Attachment 6 - Wollongong DCP 2009 - Chapter 14 - Innovation Campus Assessment

Notional Staging

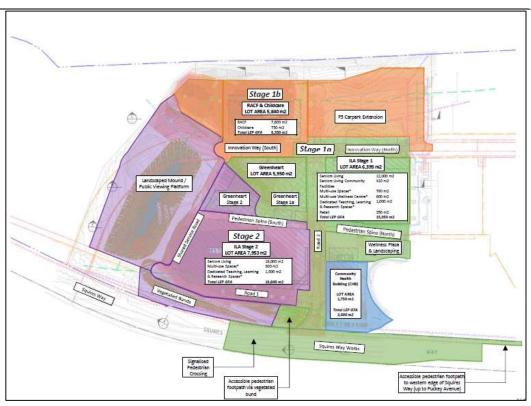
Standards/controls	Comment	Compliance
Strategy is linked to the following stages of development: Total Development (GFA sqm)	The UOW and WCC have commenced discussions around the review of the Master plan.	
55,000m2 Stage 1 - Complete 95,000m2 Stage 2	Agreement has been reached between WCC and UoW on a program for progressing the DCP review as a priority.	
135,000m2 Stage 3 (Ultimate) Section 19.2 identifies the general order of works as a notional staging strategy.
